PRODUCT MODIFICATION NOTICE: TRILENNIUM® HANDSET UPDATES

Endura Products has implemented several modifications to our Trilennium (formerly W&F Hardware) Handsets for the Trilennium Multi-Point Locking System. These modifications serve to improve performance and durability of the product over time based on observed field conditions and feedback, and are either effective immediately or in the near future as part of a rolling change.

Handsets Affected: Eclipse, Eclipse Grip, Pinnacle, Curved and Rectangular. Horizon is **NOT** impacted.

DESIGN UPDATES: LEVER/CARTRIDGE SCREW MODIFICATIONS

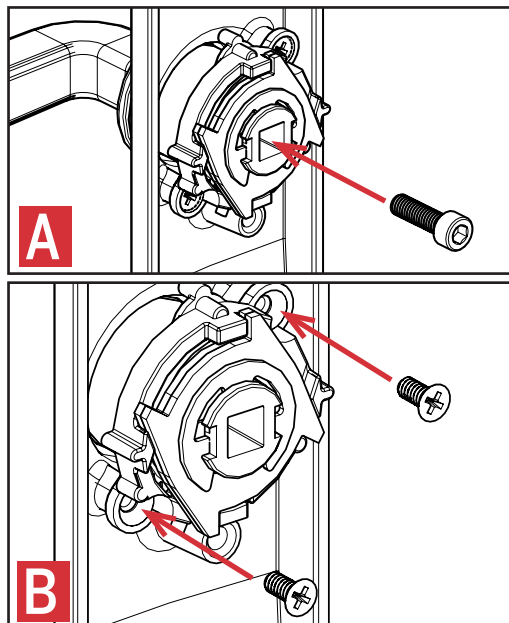
EFFECTIVE IMMEDIATELY: LEVER/CARTRIDGE SCREW MODIFICATIONS**FIELD CONDITION: LOOSE/"WOBBLY" HANDSET LEVER HANDLE**

Handset lever handle felt loosely secured to the escutcheon. In these cases, one of two issues was present: either the handle was loosely secured to the cartridge (addressed in solution A below) or the cartridge was loosely secured to the escutcheon (addressed in solution B below).

- A. The **handle mounting screw**, used to secure the lever into the cartridge, **(A)** has been shortened from 3/4" to 5/8". This modification prevents the screw from bottoming out inside the lever handle, which can cause the observed "loose" fit against the cartridge.
- B. The **cartridge mounting screws**, used to secure the cartridge to the escutcheon **(B)**, have been modified and now feature locking patches to improve their hold.

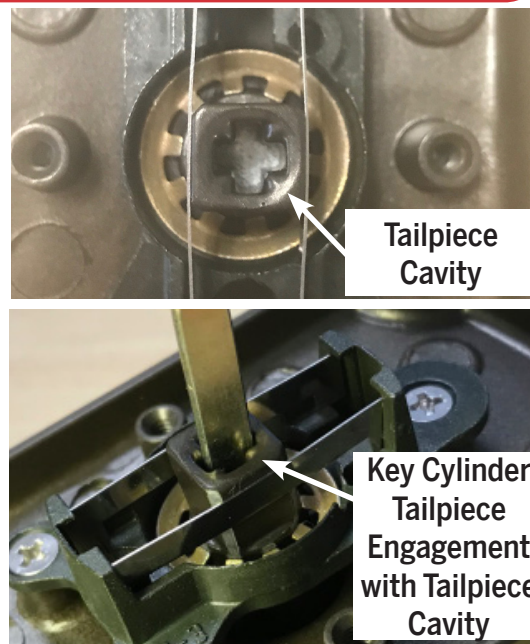
**EFFECTIVE IMMEDIATELY: ENHANCED THUMBTURN ENGAGEMENT****FIELD CONDITION: THUMBTURN TURNING BUT NOT ENGAGING BOLTS**

In some instances, turning the thumbturn did not result in turning the tailpiece of the key cylinder, which drives the dead-bolting action of the lock (the thumbturn was slipping around the end of the key cylinder piece). This prevented users from unlocking and locking the door from inside the home.

We discovered that in these specific cases only, the tailpiece cavity located on the interior of the thumbturn was washed out, worn out or out of spec. Additionally, the key cylinder tailpiece's tapered end design further reduced its ability to engage with the thumbturn, further contributing to the observed problem. While uncommon, when these factors were present, it made it difficult or impossible in some situations for the tailpiece to react based on the thumbturn's motion.

Previous Tapered-End Key Cylinder TailPiece (red outline) vs. NEW! Square-End & Longer Key Cylinder Tailpiece.

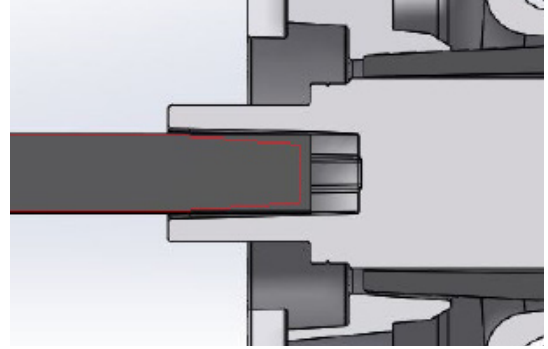
DESIGN UPDATES: TAILPIECE & TAILPIECE CAVITY MODIFICATIONS

- Effective immediately, all thumbturns with an out of spec "tailpiece cavity" have been pulled from production.
- In the near future (3-4 months), as part of a rolling change, all Trilennium thumbturns will boast a narrower tailpiece cavity, and all key cylinder tailpieces will be 0.60" longer and feature a square vs. tapered design for better engagement and consistent operation over time.
